SUPPLEMENT NO. 3
TO THE
SAFETY EVALUATION
BY THE
DIRECTORATE OF LICENSING
U. S. ATOMIC ENERGY COMMISSION
IN THE MATTER OF
DUKE POWER COMPANY
OCONEE NUCLEAR STATION UNIT 1
DOCKET NO. 50-269

TECHNICAL REPORT ON
DENSIFICATION OF BABCOCK & WILCOX REACTOR FUELS

Date: July 6, 1973

Figure 2.1 Fuel Temperatures - TAFY Predicted and Experimental (WCAP-2923)

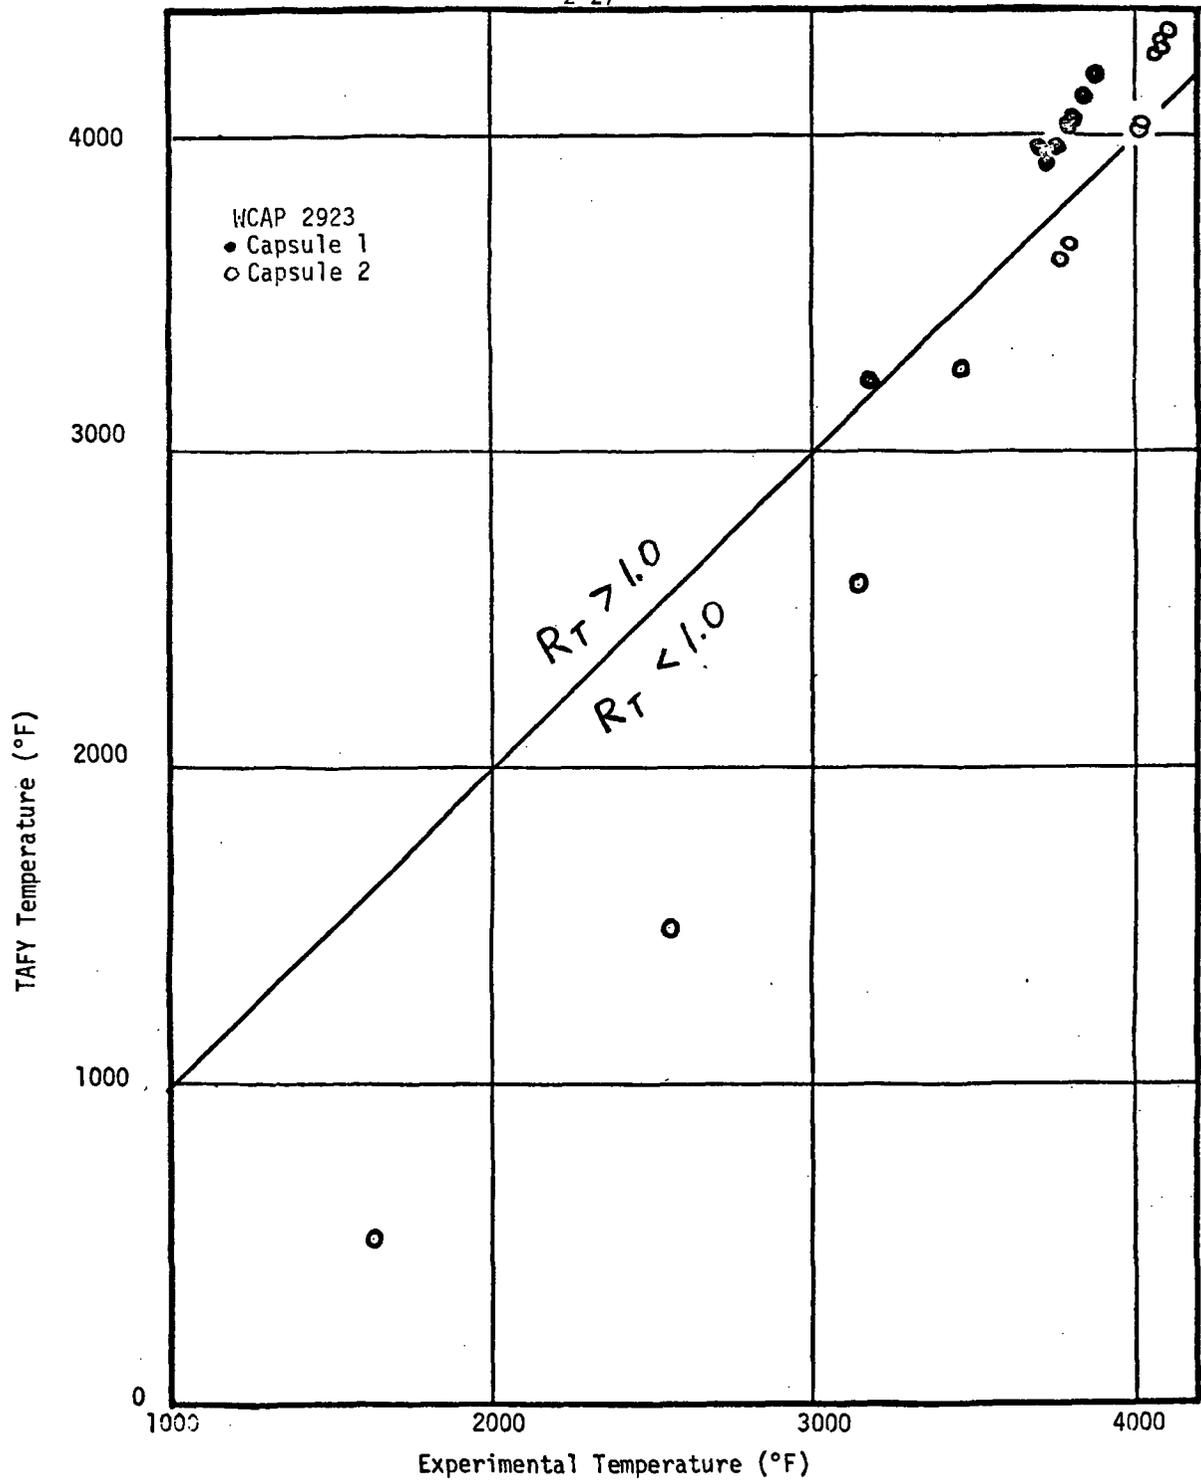
TAFY predicted temperatures is shown in Figure 2.1, which also includes two data points at low linear heat rates that were not considered in Table 2.

Figure 3.1 Location and Identification of Rod and Channel Geometry in Fuel Assembly As Used in COBRA IIIc Analyses for Oconee 1.

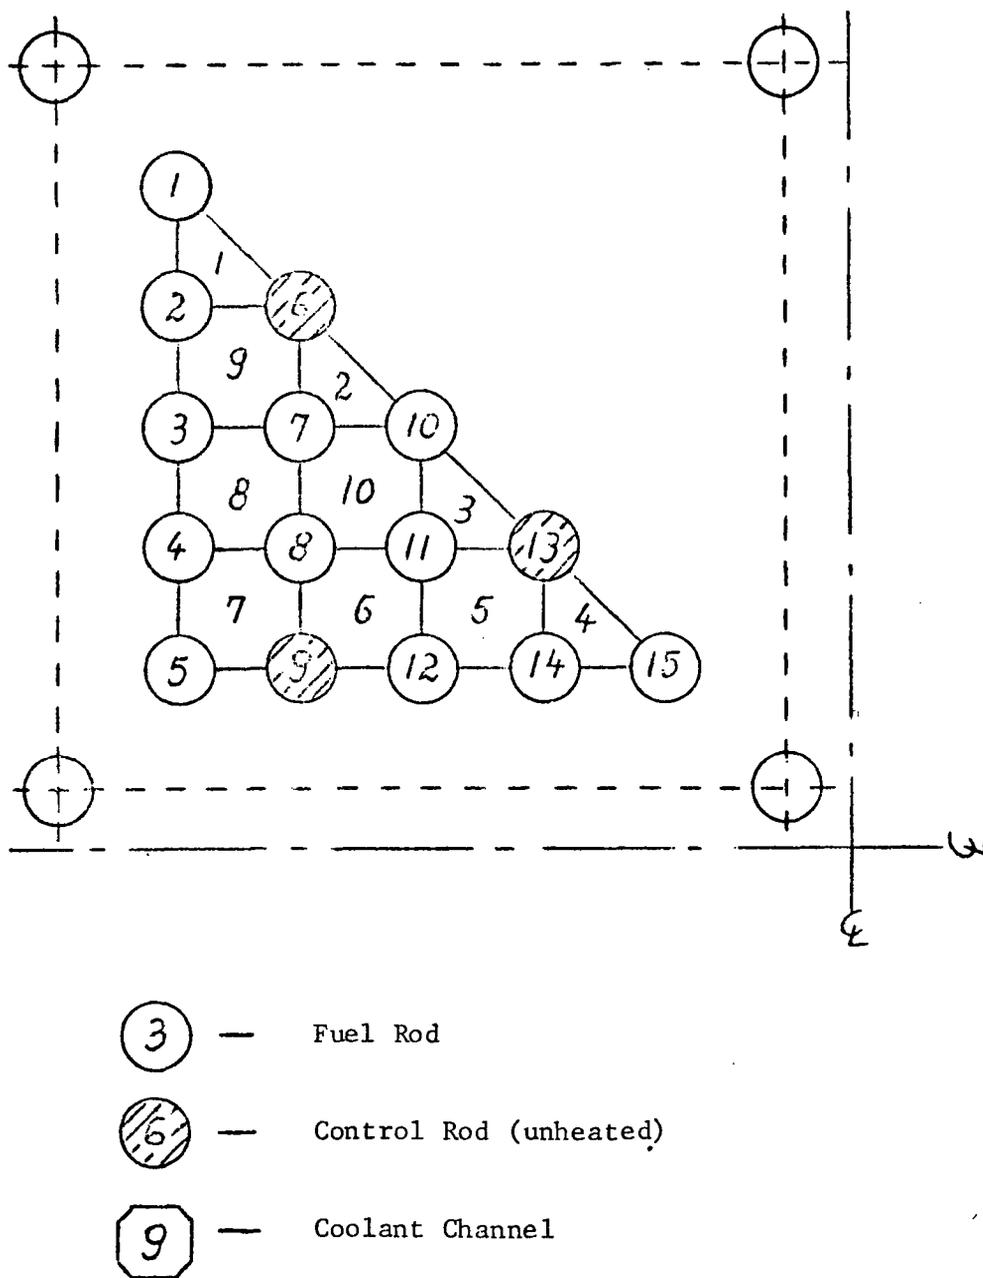
To compare B&W's thermal-hydraulic code predictions to the staff's COBRA-IIIC predictions, the specific first cycle fuel characteristics of Duke Power Company's Oconee 1 (the prototype of B&W designed reactors) were used. First cycle fuel characteristics from other B&W designed reactors are similar to those for Oconee 1. The staff evaluations were performed for a rod bundle consisting of 15 rods (12 fuel rods and 3 control rod guide tubes), which is part of the hottest assembly in the core. Identification of sub-channels and rods are shown in Figure 3.1. The following conditions apply to the events analyzed:

- c. Coolant inlet flow to the hot subchannel (channel #10) is reduced to 95% of the hot assembly average flow and flow to all other subchannels of the bundle (Figure 3.1) is reduced to 99%.

Figure 3.2 Minimum DNBR for Loss of Flow Transient
as Calculated by COBRA III-C
for Oconee 1

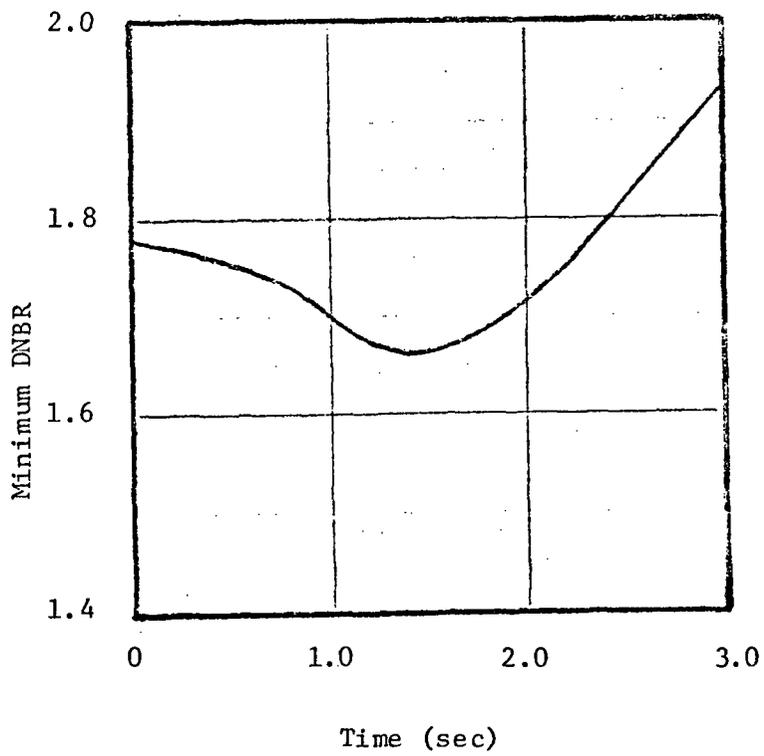
The staff also conducted an independent calculation of the loss-of-flow transient. The transient DNBR predicted by COBRA for the LOF event are shown in Figure 3.2. The appropriate flow reduction and

Figure 4.1 Maximum Clad Temperature for Locked Rotor Accident As Calculated by COBRA III-C for Ocone 1

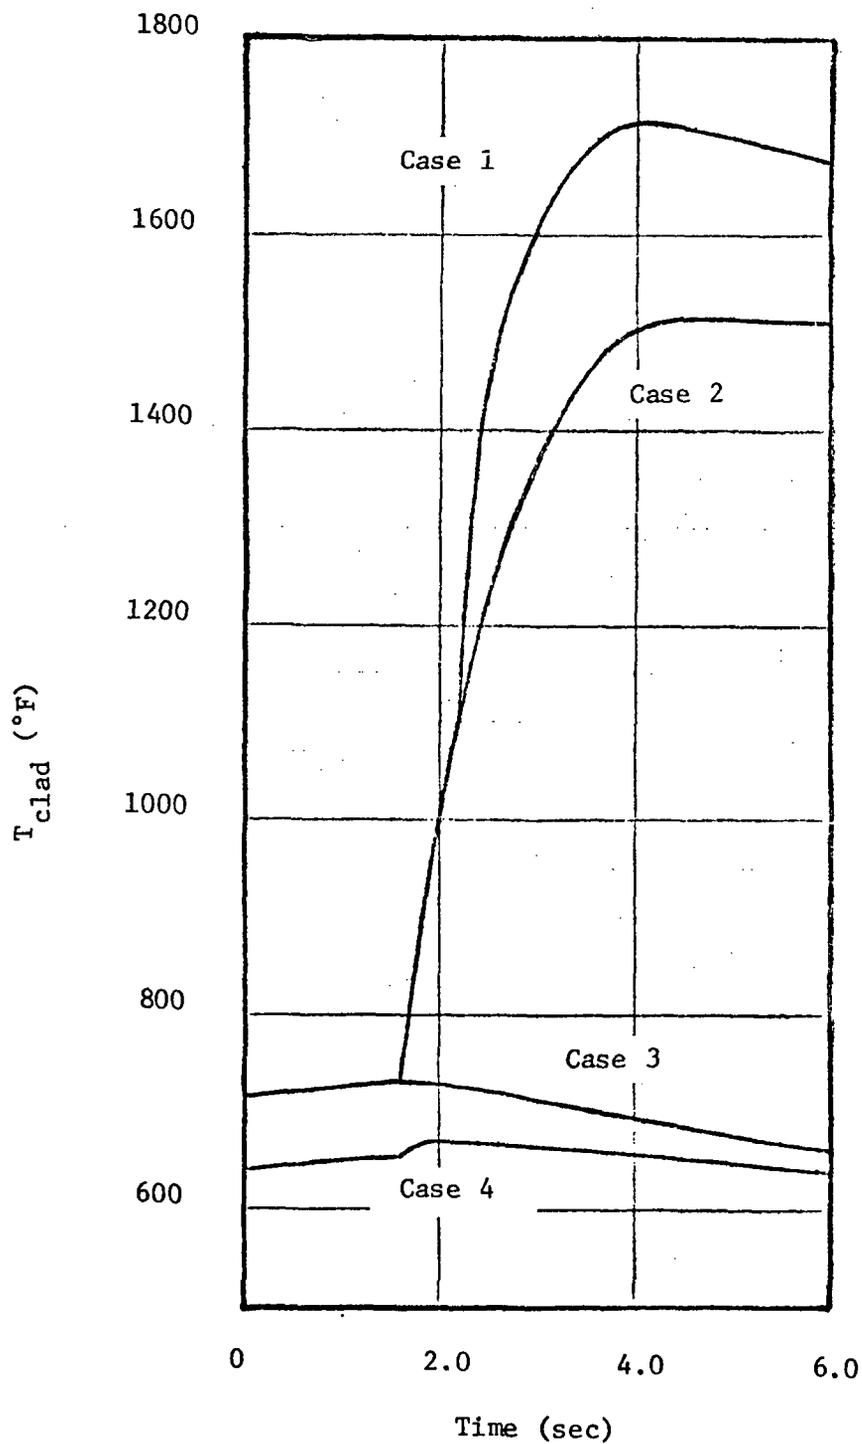
Four cases are presented in Table 4.2 and Figure 4.1 showing the effect of various conservative assumptions on the consequences of the locked rotor accident. The following parameters were varied: the gap conductance, the cladding collapse during the accident (which increases the gap conductance), and the heat transfer regime assumed. Case 1 in Table 4.1 is the most conservative combination of all parameters: a low initial gap conductance (420 Btu/hr ft °F) is assumed; the cladding is assumed to collapse onto the hot fuel pellets when the peak cladding temperature exceeds 1100°F thus transferring stored heat to the cladding; and fully developed flow film boiling is assumed whenever the DNBR drops below 1.3. This case results in a peak cladding temperature of 1720°F at 4.2 seconds. Case 2 is similar to Case 1 except that cladding collapse is not assumed. This case resulted in a peak cladding temperature of 1520°F. A constant gap conductance of 825 Btu/hr ft²°F (the approximate value used by B&W for the Oconee 1 evaluation) is assumed for Case 3. In this case the DNBR drops to
